#### ZONE CHANGE REVIEW SHEET

**CASE**: C814-88-0001.10

Canyons @ Rob Roy Rezoning

Staff recommends Planned Unit Development (PUD) zoning with the following changes to Exhibit "H" of the PUD Land Use Plan -

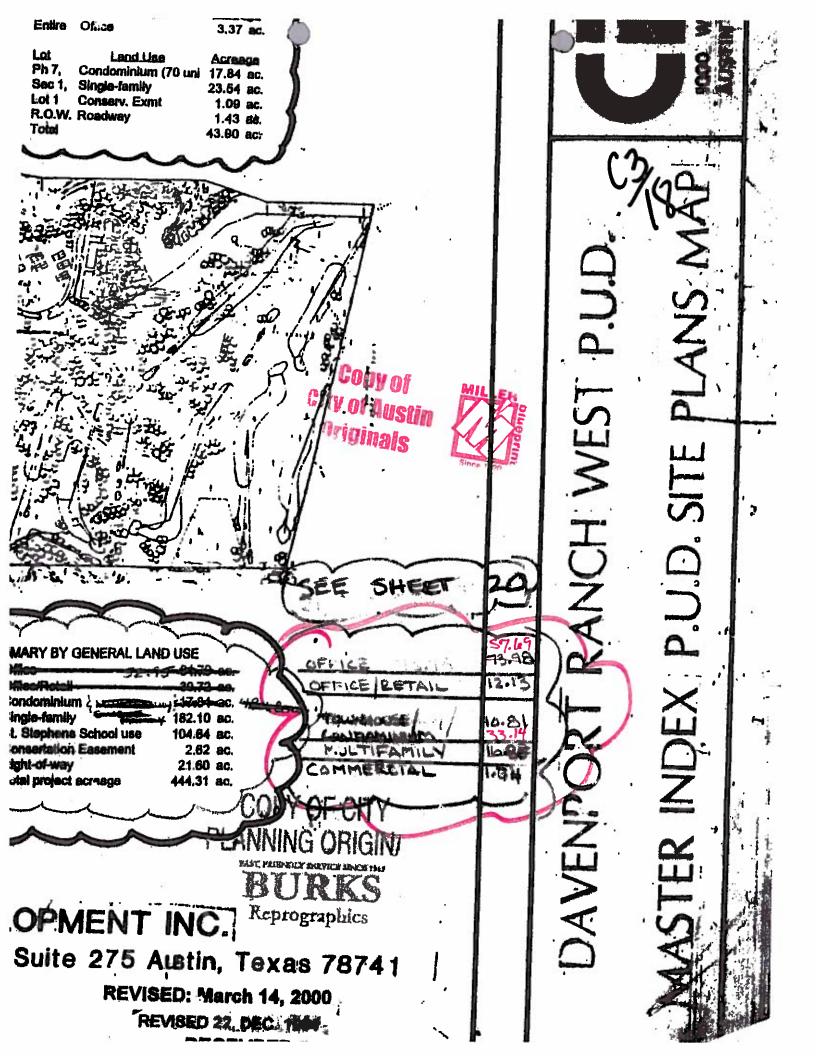
Exhibit "H" Land Use Plan. Change the Overall Summary by General Land Use Table on Sheet 1 to reflect a change from office use to multifamily use; adjust the acreages accordingly.

Exhibit "H" Land Use Plan. Change the Land Use Summary Table on Sheet 1 to reflect the correct lot and change the proposed land use from office to multifamily.

Justification. The Property was zoned for office use in 1988, since then it has remained undeveloped. West Austin lacks a sufficient supply of multifamily development for families looking to move to the area that otherwise might not be able to afford owning their own home. The few multifamily developments located in the surrounding area experience an occupancy rate of over 90%. Additionally, the proposed low density multifamily residential use provides a better transition between Capital Texas Highway located to the west and the residential uses located to the north and east of the site.

Justification. The Property was zoned for office use in 1988, since then it has remained undeveloped. West Austin lacks a sufficient supply of multifamily development for families looking to move to the area that otherwise might not be able to afford owning their own home. The few multifamily developments located in the surrounding area experience an occupancy rate of over 90%. Additionally, the proposed low density multifamily residential use provides a better transition between Capital Texas Highway located to the west and the residential uses located to the north and east of the site.

## OVERALL ORDINANCE INFORMATION

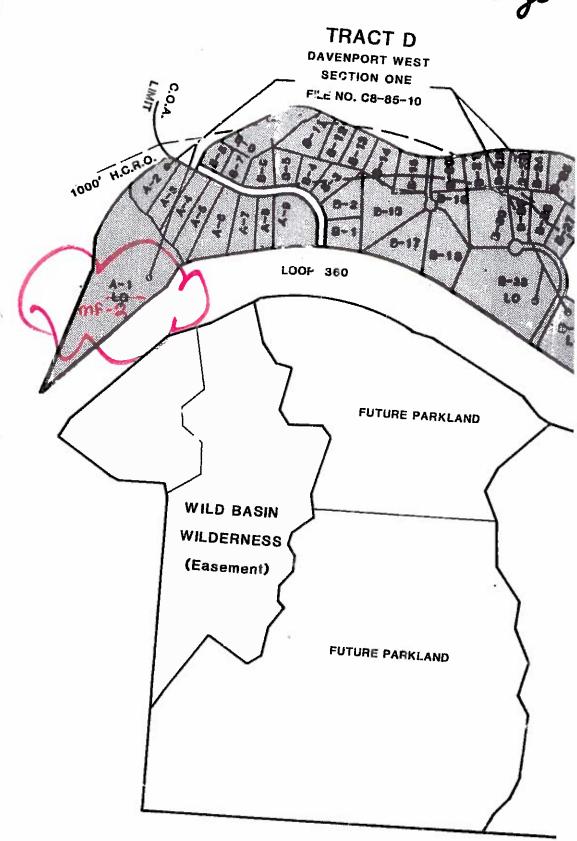
Exhibit "H" Land Use Plan. Clarify Ordinance Compliance Note #1 on Sheet 2 to read "Single family" residential areas are limited to a density of one unit per two acres of gross site area, with minimum one acre lots."

Exhibit "H" Land Use Plan. Change the Hill County Roadway Ordinance Calculations on Sheet 2 to deduct the site area calculations of Lot A-1.

Exhibit "H" Land Use Plan. Change the F.A.R & Parking Summary Table on Sheet 2 to reflect Lot A-1 as a multifamily project.

Exhibit "H" Land Use Plan. Change the diagram on Sheet 2 for Lot A-1 from "LO" to "MF-2".

Justification. As supported by Section 1.04 of the Restrictive Covenant recorded in Volume 10909, Page 1601 of the Real Property Records of Travis County, Texas for the Davenport Ranch West Planned Unit Development Section One, this restriction was intended to apply solely to single family residential development. I have attached a copy of the Restrictive Covenant for your reference with the companion Restrictive Covenant Amendment case.

Justification. Per the Hill County Roadway Ordinance the floor to area limitations only apply to nonresidential buildings.

Justification. The parking table only provides parking calculations associated with the office development on Tract D. Since the use is changing from office to multifamily we have updated the table accordingly.

Justification. The Property was zoned for office use in 1988, since then it has remained undeveloped. West Austin lacks a sufficient supply of multifamily development for families looking to move to the area that otherwise might not be able to afford owning their own home. The few multifamily developments located in the surrounding area experience an occupancy rate of over 90%. Additionally, the proposed low density multifamily residential use provides a better transition between Capital Texas Highway located to the west and the residential uses located to the north and east of the site.

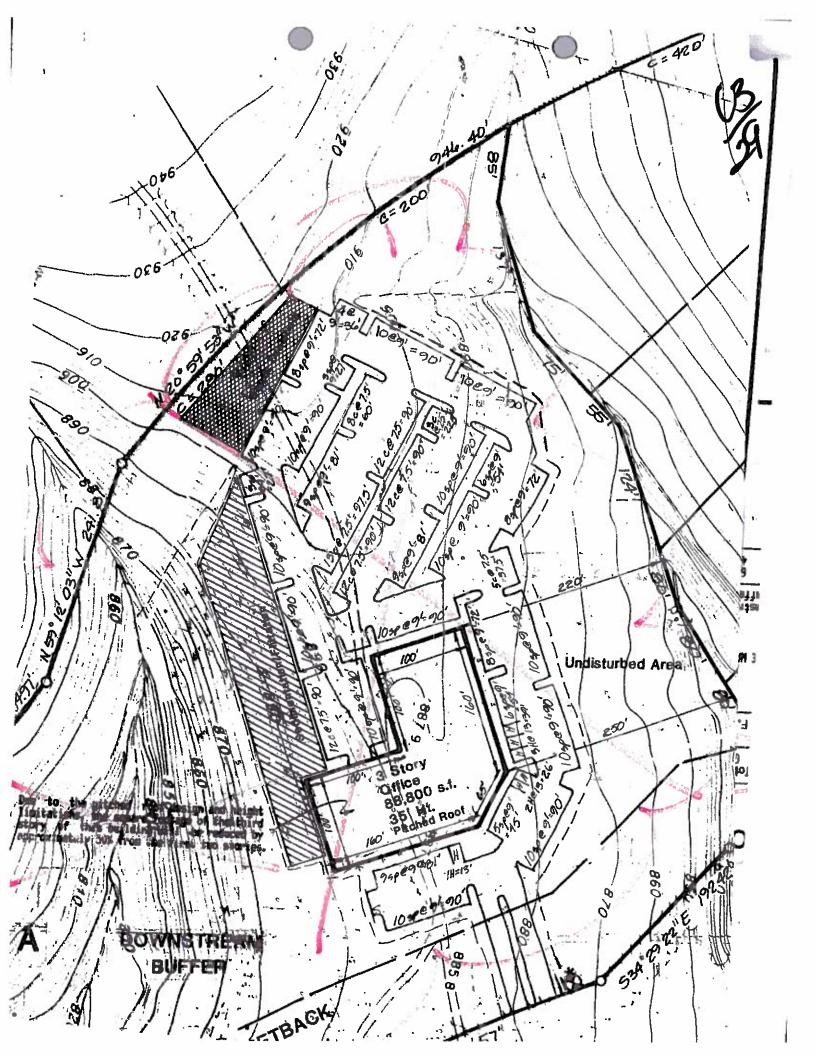
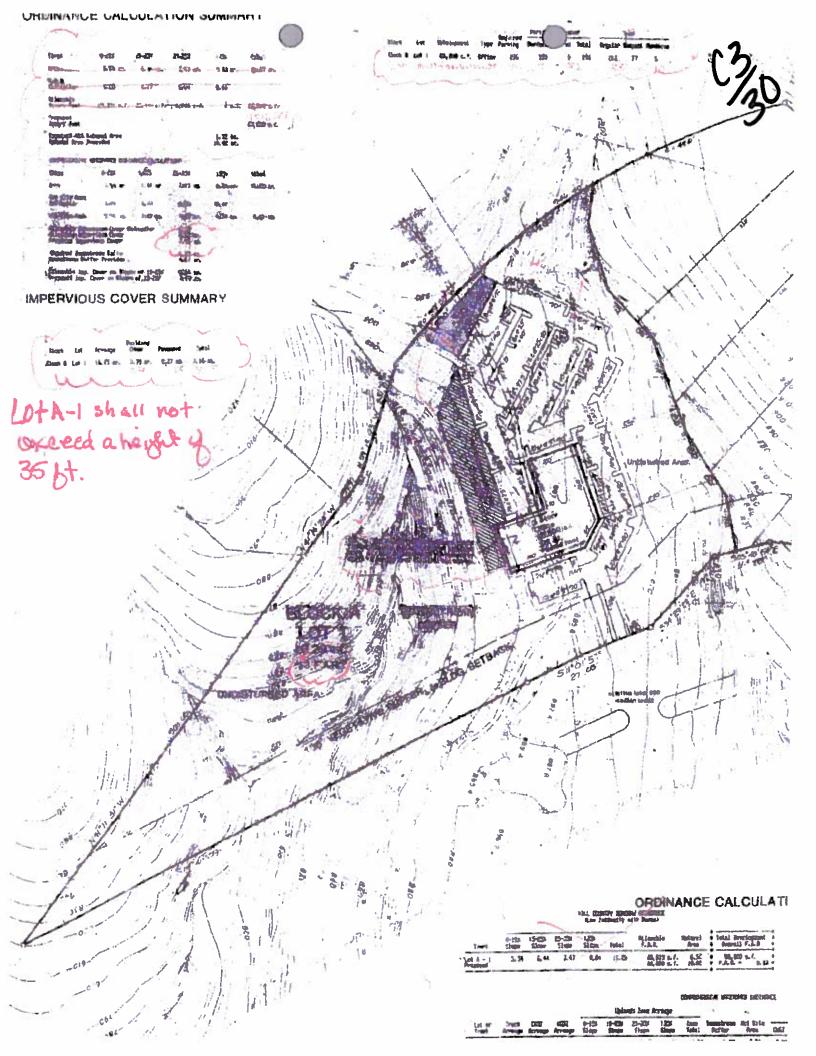
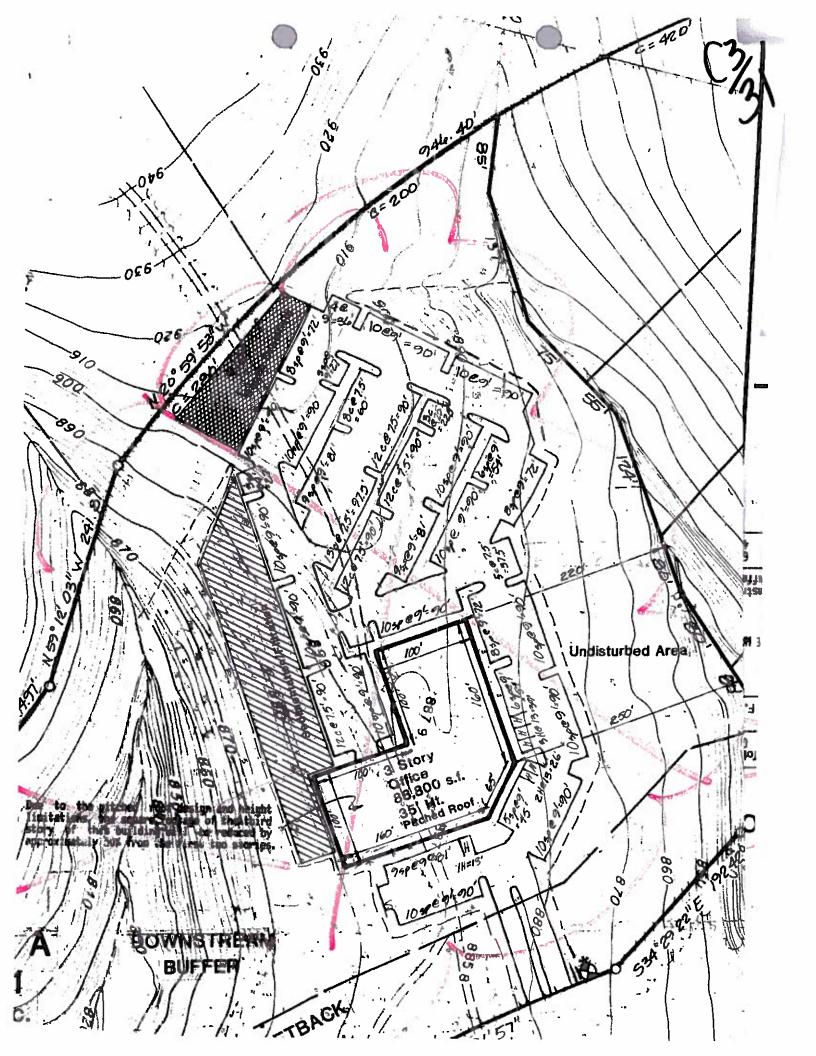
Exhibit "H" Land Use Plan. Remove the floor to area multiplier calculations and the allowable square footage calculations on Sheet 3.

Exhibit "H" Land Use Plan. Change the proposed impervious cover from 3.16 acres to 3.50 acres.

Exhibit "H" Land Use Plan. Change the Impervious Cover Summary Table on Sheet 3 to reflect the proposed impervious cover and to account for a different building configuration and parking layout.

Exhibit "H". Land Use Plan. Remove the Hill County Roadway Ordinance Table on Sheet 3.

Exhibit "H" Land Use Plan. Change the Comprehensive Watershed Ordinance Table on Sheet 3 to reflect the proposed impervious cover.

Exhibit "H" Land Use Plan. Remove the diagram on Sheet 3 of the office project.

Exhibit "H" Land Use Plan. Add a note on Sheet 3 that clarifies the maximum height allowed on Lot A-1 is 35 feet.

Exhibit "H" Land Use Plan. Remove the note on Sheet 3 that reads "Due to the pitch of the roof design and height limitations the square footage of the third story of this building will be reduced by approximately 50% from the first two stories.

Justification. Per the Hill County Roadway Ordinance the floor to area limitations only apply to nonresidential buildings.

Justification. While the proposed impervious cover is slightly more than the previous office project, this project is still under the 3.52 acres of impervious cover allowed for Lot A-1.

Justification. While the proposed impervious cover is slightly more than the previous office project, this project is still under the 3.52 acres of impervious cover allowed for Lot A-1. The prior office project proposed a vast amount of surface parking with a small building footprint. Since the use of the site is changing from office to multifamily the size and configuration of the building and parking area must also change to accommodate a more user friendly development. The proposal is to provide a wrapped product type with structured parking within.

Justification. Per the Hill County Roadway Ordinance the floor to area limitations only apply to nonresidential buildings.

Justification. While the proposed impervious cover is slightly more than the previous office project, this project is still under the 3.52 acres of impervious cover allowed for Lot A-1.

Justification. Zoning is used to establish the best use for a site and should not be used to dictate the location of site improvements. This should be deferred to the site development stage when engineered documents and related reports are available to assess the proper location of improvements based on site constraints. Also by removing the diagram from the land use plan it prevents future amendments to the PUD should the location of the site improvements fluctuate slightly.

Justification. There is no change from the previous proposal.

Justification. This note is unnecessary since the building is limited to 35 feet with height limit exceptions, as prescribed by 25-2-531 of the City Code, for certain architectural elements including pitched roof designs.
